Dixie-Narco®

311A

MODEL: DNCB CC Coke Venders

SUBJECT: Installation
Maka Validator
Model: NB10 using NB15A nose piece.

Bottom
Fig. 1
Validator Mounting Ring

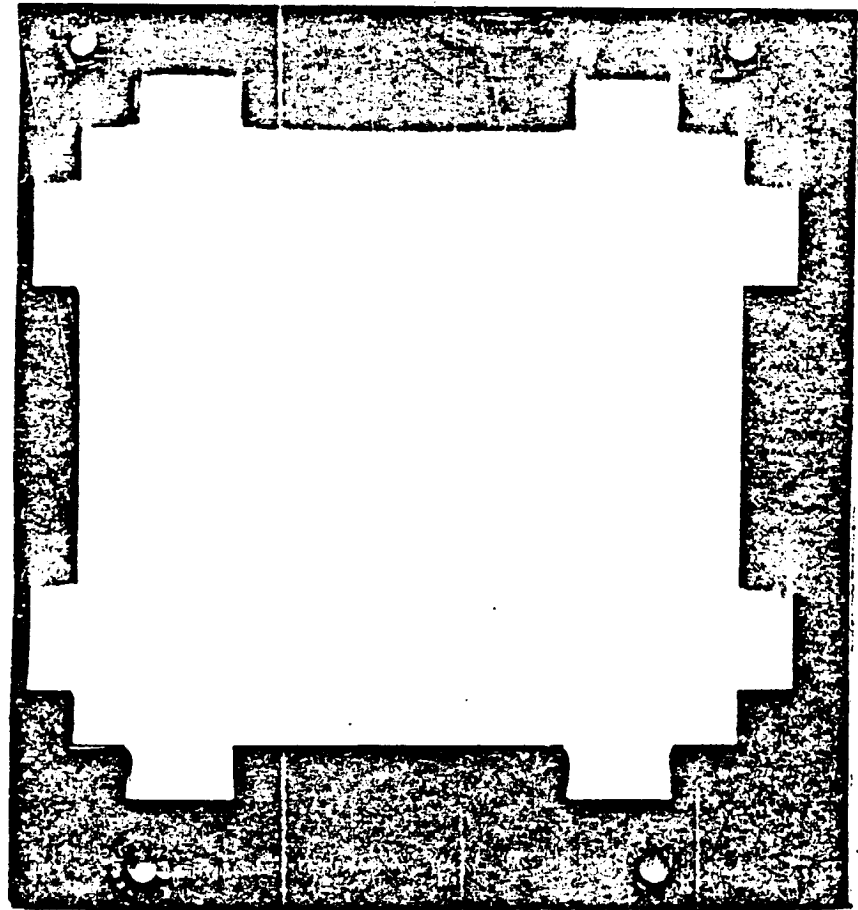
- DO THIS:
1. Remove the Validator cover plate from the vender's Main Door.
 - 2a. Remove the two (2) Coin Insert Retainers - Fig. 3.
 - b. Replace these with POS Window Retainer - Fig. 2.
 - 3a. Some Venders will have a Coin Insert Retainer which is almost identical to Fig. 2.
 - b. If the Vender's Serial Number is not 0001-2967 or higher, replace the Retainer.
 - 4a. Install the Validator Mounting Ring (bottom down - Fig. 1) in the opening from which the Validator Cover Plate was removed.
 - b. Once inserted, install four (4) keps nuts (as spacers) on top studs and two (2) 5/16 Stand Off (as spacers) on the bottom studs.
 - 5a. From the rear of the Main Door, align the nose piece of the Validator with the Validator opening, and push through.
 - b. Align Validator holes with Mounting Ring Studs and secure Validator with Keps Nuts.
